Marin Headlands and Fort Baker Transportation Infrastructure and Management Plan

Final Environmental Impact Statement

March 2009

Final Environmental Impact Statement Marin Headlands and Fort Baker Transportation Infrastructure and Management Plan

FIGURE 4.2 PEAK-SEASON WEEKEND TRAFFIC VOLUMES — YEAR 2023

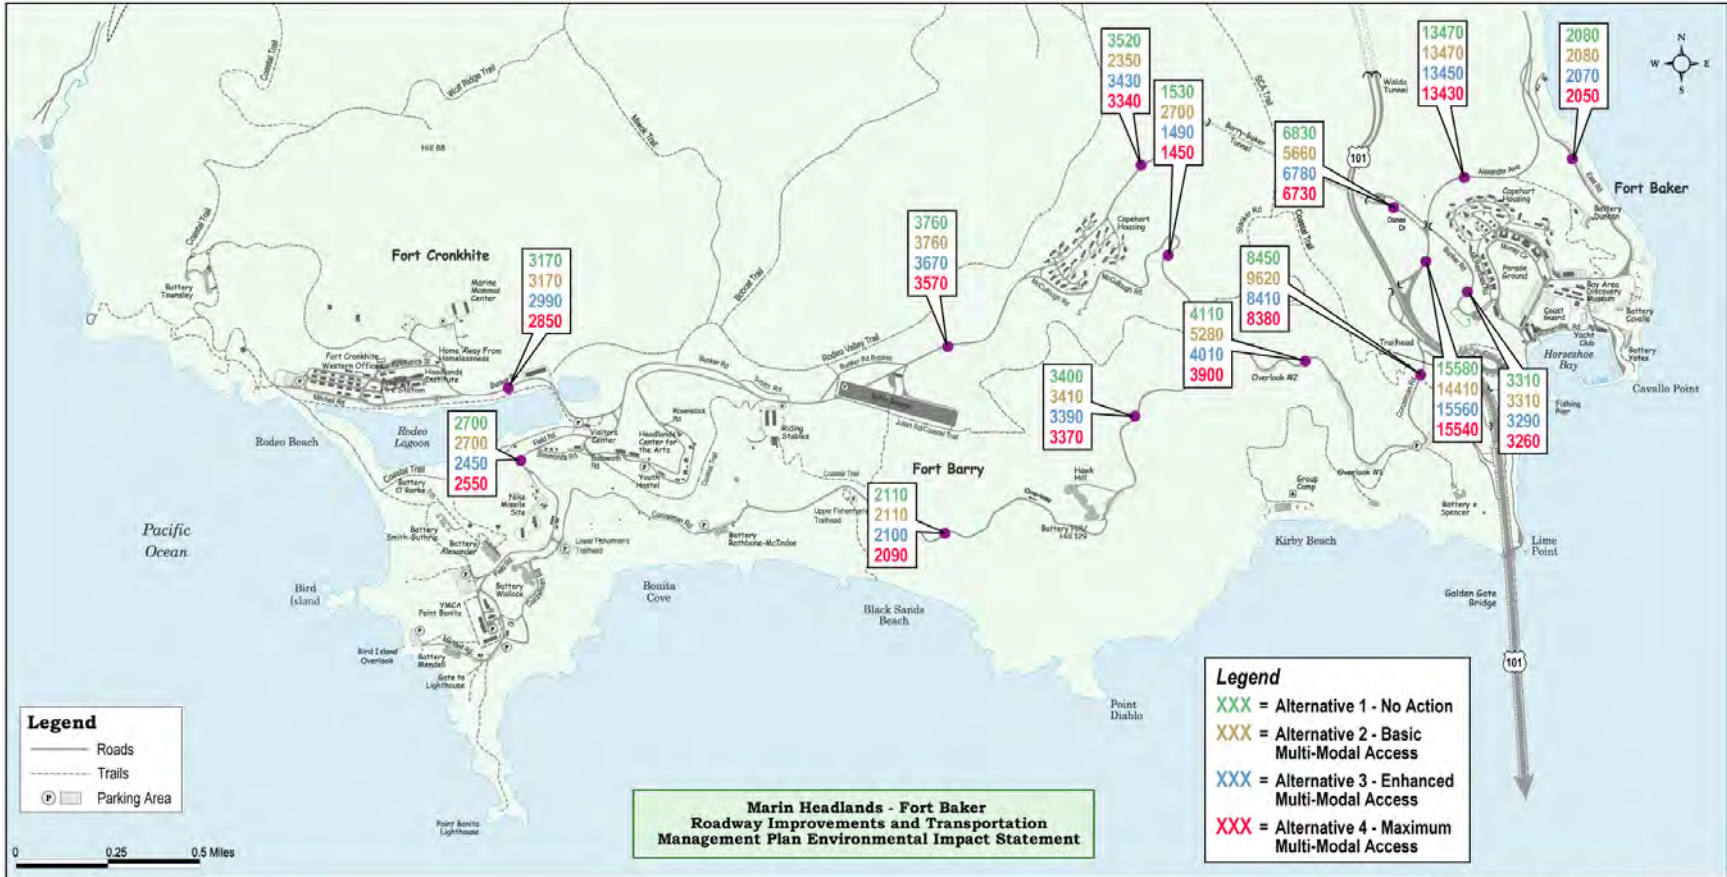
| <p>9. Section 4.2.2, Traffic, Figure 4.2 provides estimated 2023 traffic levels. LOS analysis of Alexander Avenue at Highway 101 and Danes Drive for the four alternatives is referenced without supporting data. Results for Alternatives 1 and 3 are summarized as "no change" and "negligible", while Alternative 2 notes that Alexander/Danes "could be signalized" to avoid minor adverse impacts on LOS, and Alternative 4 notes the possibility of a signal despite negligible LOS impact. District requests that detailed traffic analysis data be presented in the EIS to support findings.</p> | <p>J-11</p> |

Section 4.2.2, Traffic, Figure 4.2 provides estimated 2023 traffic levels. LOS analysis of Alexander Avenue at Highway 101 and Danes Drive for the four alternatives is referenced without supporting data.
